Item Name: Aft Crosstube - Mid Height 206L / L1 / L3 / L4, Blue

DART AEROSPACE LTD		Work Order:	135694
Description: Crosstube Mid Aft (206L)		Part Number:	D206-667-207
Inspection Dwg: D206-667-247	Rev: A		Page 1 of 1

DRAWING NO. REV. A
D206-667-247 SHEET 1 OF 4

DRAWING NO. D206-667-247	TITLE CROSSTUBE ASS'Y (206L MID AFT)	REV. A	DART AEROSPACE LTD ENGINEERING ORDER		D.E.O. NO. D206-667-247-A-1	SHEET NO. SHEET 1 OF 1	SCALE NTS
DRAWN 92	CHECKED ASS	MFG. APPR. KB	APPROVED JMP		DE APPR. H		
DATE 11.07.15	DATE 11.07.20	DATE 11.07.21	DATE 11/07/21		DATE 11.07.21

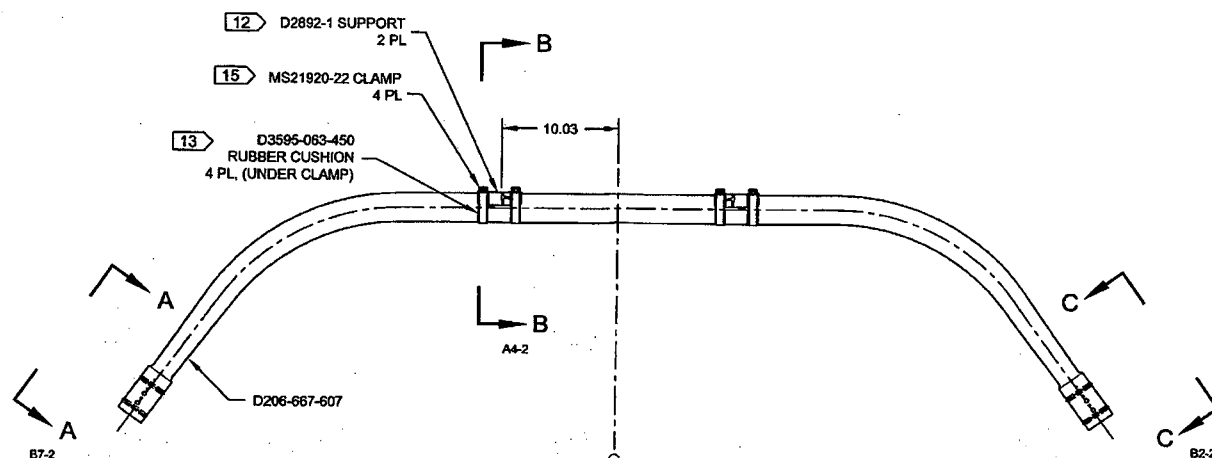
PURPOSE:

REPLACE MAGNOBOND WITH PROSEAL.

IS:

Item	Qty -247	Part Number	Description
9	A/R	PROSEAL 890 B-2	SEALANT, AMS-S-8802 CLASS B-2

WAS:

9	A/R	MAGNOBOND 6398	ROCKWELL SPECIFICATION RBO-120-023 ADHESIVE (TEXTRON/BELL SPEC. 299-947-100, TYPE II, CLASS 2 ADHESIVE)
---	-----	----------------	---

NOTE 12 & 15, SHEET 1 IS AMENDED AS FOLLOWS:

WAS:

- 12) INSTALL D2892-1 SUPPORT USING 0.03" TO 0.06" THICK LAYER OF MAGNOBOND 6398 PER QSI 015. LET CURE FOR 12 HOURS AFTER INSTALLATION AND PRIOR TO PACKAGING.
- 15) TORQUE CLAMPS 80 TO 100 IN-LB. ENSURE AT LEAST 1.5 THREADS SHOWING IN SAFETY AND THAT NUT HAS NOT BOTTOMED-OUT AFTER TORQUING.

- 12) TO INSTALL D2892-1 SUPPORT: ABRASE MATING SURFACE OF SUPPORT AND CROSSTUBE WITH 180-GRIT SANDPAPER AND REMOVE RESIDUE WITH MEK (OR EQUIVALENT). APPLY A 0.04" TO 0.07" THICK LAYER OF PROSEAL 890 CLASS B-2 (OR AMS-S-8802 CLASS B-2) SEALANT TO MATING SURFACE OF SUPPORT.
- 15) TORQUE CLAMPS 80 TO 100 IN-LB. ENSURE AT LEAST 1.5 THREADS SHOWING IN SAFETY AND THAT NUT HAS NOT BOTTOMED-OUT AFTER TORQUING. **PRIOR TO PACKAGING, RE-CHECK TORQUE ON CLAMPS AFTER PROSEAL 890 SEALANT HAS CURED FOR 72 HOURS.**
